SERIAL: HNP-03-075

**SHEARON HARRIS NUCLEAR POWER PLANT, UNIT NO. 1
DOCKET NO. 50-400/LICENSE NO. NPF-63
CYCLE 12 CORE OPERATING LIMITS REPORT**

SUMMARY OF CYCLE 12 COLR REVISIONS

Harris Unit 1 Cycle 12
Core Operating Limits Report - Rev. 0

Figure 2

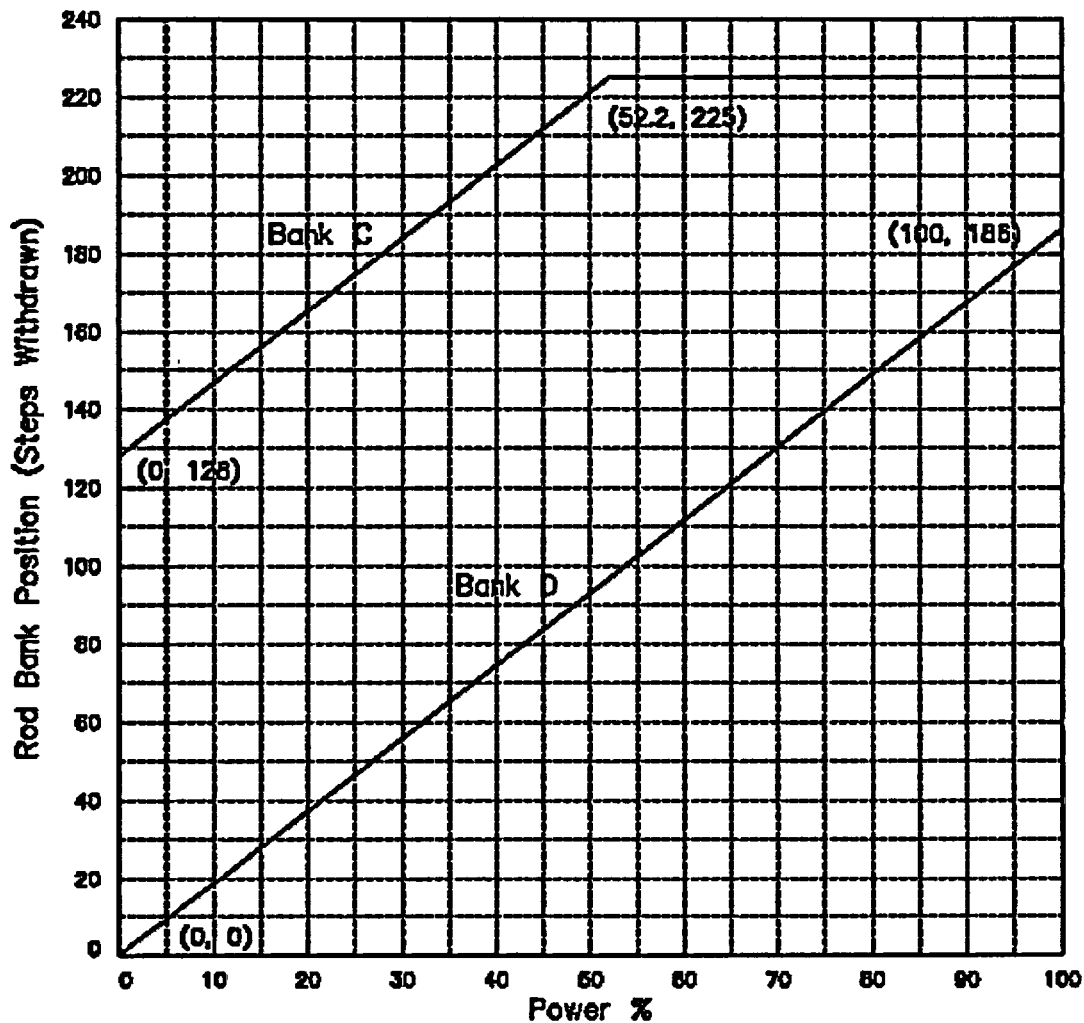
1.0	Revised from Cycle 11 to Cycle 12	1
2.2	Item 2: Change -42.7 pcm/°F to -42.6 pcm/°F	1
2.3	Changed fully withdrawn rod position from 231 to 225	1
2.4	Changed fully withdrawn rod position from 231 to 225	1

(Fully withdrawn shall be 225 steps)

Figure 6
V(Z) Versus Core Height

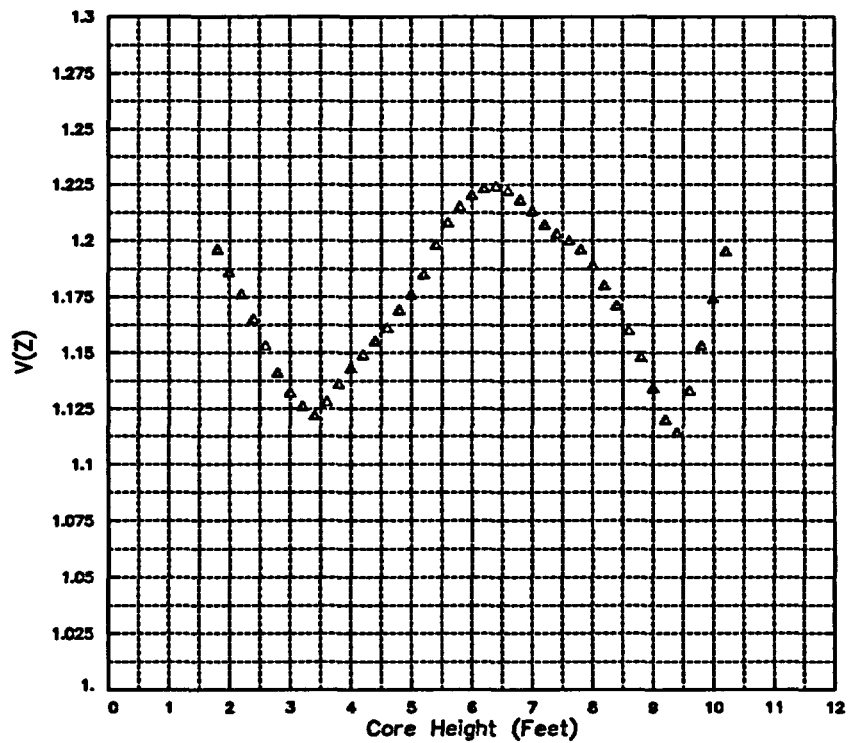
3.0.13 (New)	Added methodology EMF-2328 (A)	2
3.0.14 (New)	Created new Mechanical Methodologies section with methodologies from page 73 section 3.0.6. Moved items between pages 73 and 74 to accommodate changes. Added “, and Letter, R. A. Copeland (SPC) to R. C. Jones (USNRC), RAC: 050: 91, dated May 13, 1992” to fifth paragraph	2
Figure 1	Changed Figure 1 to reflect the new Cycle 12 information	1
Figure 2	Changed Figure 2 to reflect the new rod park position of 225 steps for Cycle 12	1
Figure 4	Changed Figure 4 to reflect the new Cycle 12 information	1
Figure 5	Changed Figure 5 to reflect the V(Z) curve for Cycle 12 operation up to 16000 MWD/MTU	1
Figure 6	Changed Figure 6 to reflect the V(Z) curve for Cycle 12 operation for burnups from 16000 MWD/MTU through 20936 MWD/MTU	1

- Top and bottom 15% excluded as per Technical Specification 4.2.2.2.
- (Figure 6) is valid for Cycle 12 burnups greater than or equal to 16000 MWD/MTU to a maximum cycle energy of 20936 MWD/MTU.
